REMARKS

Drawings

FIG. 4

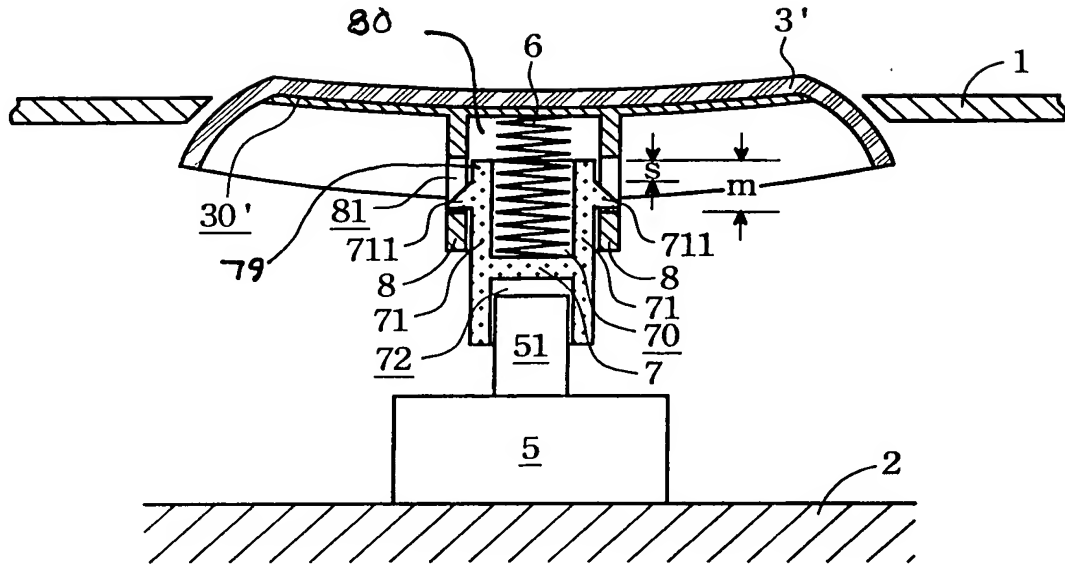
Applicant proposes to amend Figure 4 as illustrated in red on the attached photocopy. In Figure 4 it is proposed to add the labels --79-- and --80--. No "new matter" has been added to the original disclosure by the proposed amendments to this figure. It is believed that the foregoing proposed amendments obviate the outstanding objections to the drawings. Approval of the proposed drawing changes is respectfully requested.
